**SUBJECT: Safety Recall 20S63 – Supplement #1**  
 Certain Front Wheel Drive 2014-2015 Model Year Taurus, 2014-2016 Model Year Explorer, and 2014 Model Year Edge Vehicles Equipped with a 2.0L or 2.3L Engine Front Halfshaft Bracket Replacement

**New! REASON FOR THIS SUPPLEMENT**

FIGURE 1

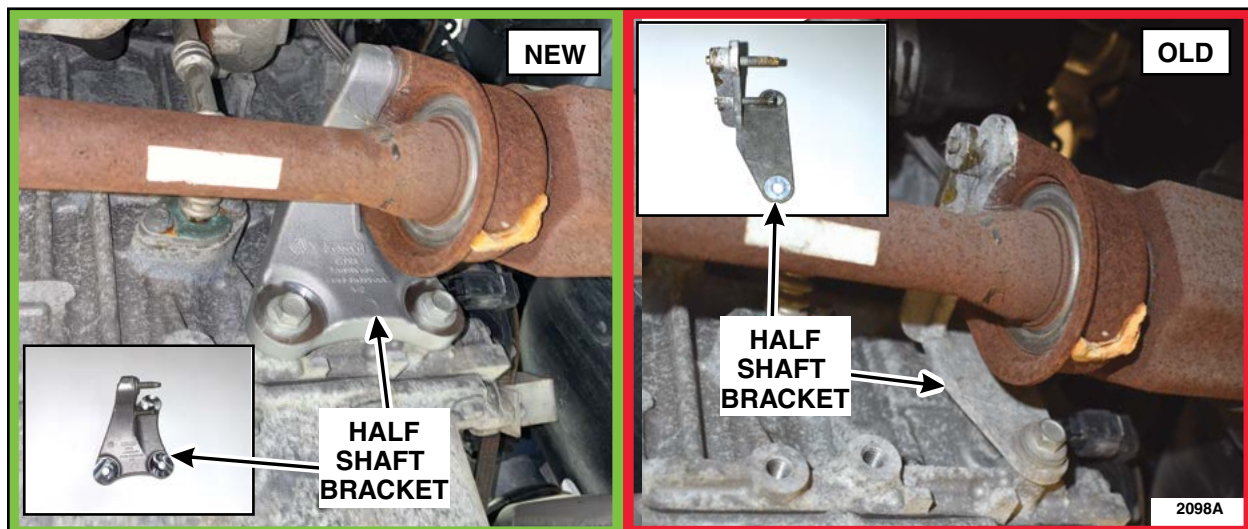
**NEW !** 2. *Inspect the Right Hand (RH) side half shaft bracket. Is the new style bracket already installed? The new bracket will have three mounting bolts, the old style bracket will have two. See Figure 1.*

**NOTE:** To see the old and *new* half shaft bracket. See Figure 1.

*Yes - Passes Inspection, The inspection is complete, install the underbody shield, if removed.  
No - Does Not Pass Inspection, Proceed to Step 3.*

8. Install two (2) *new* half shaft bearing studs into the *new* bracket.

9. Install the *new* RH half shaft bearing bracket and three (3) bolts.
